Access Compliance Report

Public Rights-of-Way

(Curb Ramps)

Intersection ID: 42530	Main Street: CASTLETOWN_HOUSE_DR	Cross Street: RATHANGAN_DR	Location: SE
ADA ID: 0460F7460D0E	Ramp Type: PerpDiag	Initial Pass/Fail: Fail	Overall Compliance: No
Codes/Mitigation Info/Possible Solution		Field Measurements/Component Compliance	
Severity Score: 8.75

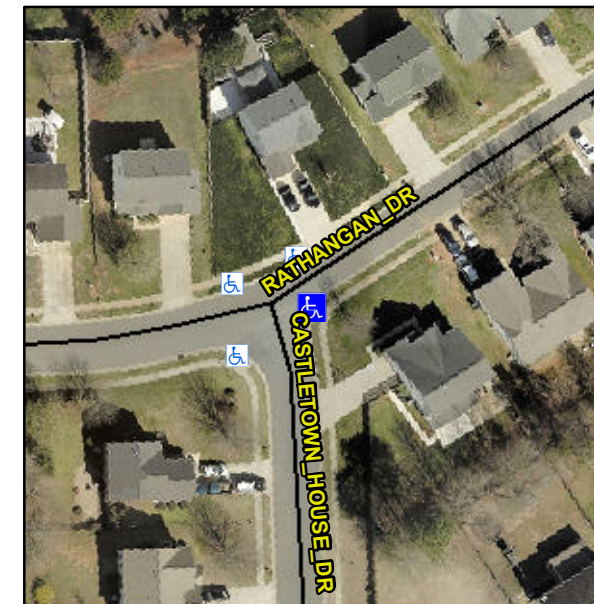
Not Found, R304.5.1

Compliance	Description	Data	Compliance	Description	Data
N/A	Ramp Length (in)	48.0	Yes	Ramp Slope (%)	7.4
No	Ramp Width (in)	40.0	Yes	Ramp XSlope (%)	0.7
N/A	Flare Type LT	N/A	N/A	Flare Type RT	N/A
N/A	Flare Slope LT (%)	N/A	N/A	Flare Slope RT (%)	N/A
N/A	Flare Traversable LT?	N/A	N/A	Flare Traversable RT?	N/A
N/A	Landing Length (in)	N/A	N/A	DWS Provided?	N/A
N/A	Landing Width (in)	N/A	N/A	DWS Contrast?	N/A
N/A	Landing Slope (%)	N/A	N/A	DWS Length (in)	N/A
N/A	Landing X Slope (%)	N/A	N/A	DWS Full Width?	N/A
N/A	Landing Curb? (Y/N)	N/A	N/A	DWS Offset (in)	N/A
N/A	Shared Landing?	N/A			
N/A	Gutter Ponding?	N/A	N/A	Gutter Slope (%)	N/A
N/A	Gutter Lip Ht (in)	N/A	N/A	Gutter X Slope (%)	N/A
N/A	Painted X Walk1?	No	N/A	Painted X Walk2?	No
	X Walk 1 Direction	To NW		X Walk 2 Direction	To SW
N/A	X Walk 1 Width (in)	N/A	N/A	X Walk 2 Width (in)	N/A
	X Walk 1 Slope (%)	0.3		X Walk 2 Slope (%)	2.5
	X Walk 1 X Slope (%)	1.9		X Walk 2 X Slope (%)	0.2

Remove & Replace Curb Ramp With Two New Directional Ramps or Equivalent.
